**RE: 2021 Rio Grande Blvd NW
Tract A-1-A Max Replat (Lots 1 & 2 Prado Del Bosque)
Conceptual Grading and Drainage Plans
Engineer's Stamp Date: 7/7/25
Hydrology File: H12D031
Case # HYDR-2025-00255**

ENGINEER'S SEAL	TRACT A-1-A MAX REPLAT LOTS 1 & 2 PRADO DEL BOSQUE	DRAWN BY DEM
DAVID SOULE P.E. #14522	CONCEPTUAL GRADING AND DRAINAGE PLAN	DATE 7-4-25
7/7/25	DAVID SOULE P.E. #14522	Lot 1 & 2 Prado Del Bosque.dwg
		SHEET # C1
		JOB #

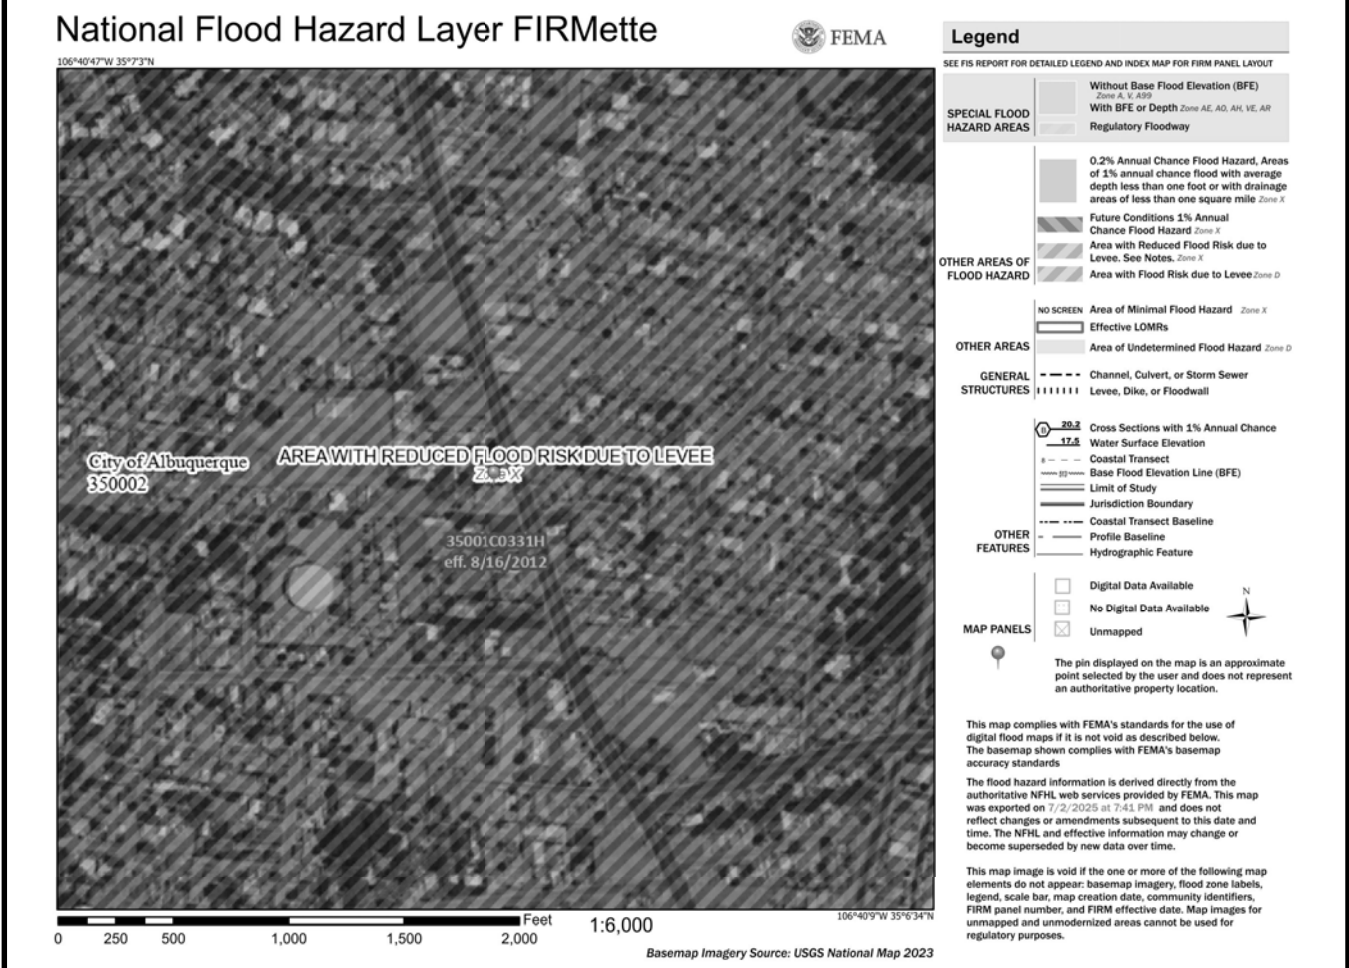
Based upon the information provided in your submittal received 07/15/2025, the Conceptual Grading & Drainage Plans are preliminary approved for action by the Development Facilitation Team (DFT) on Site Plan for Building Permit and for action by the Development Hearing Officer (DHO) on platting.

1. Please submit a more detailed Grading & Drainage Plan to Hydrology for review and approval. This digital (.pdf) is emailed to PLNDRS@cabq.gov along with the Drainage Transportation Information Sheet.
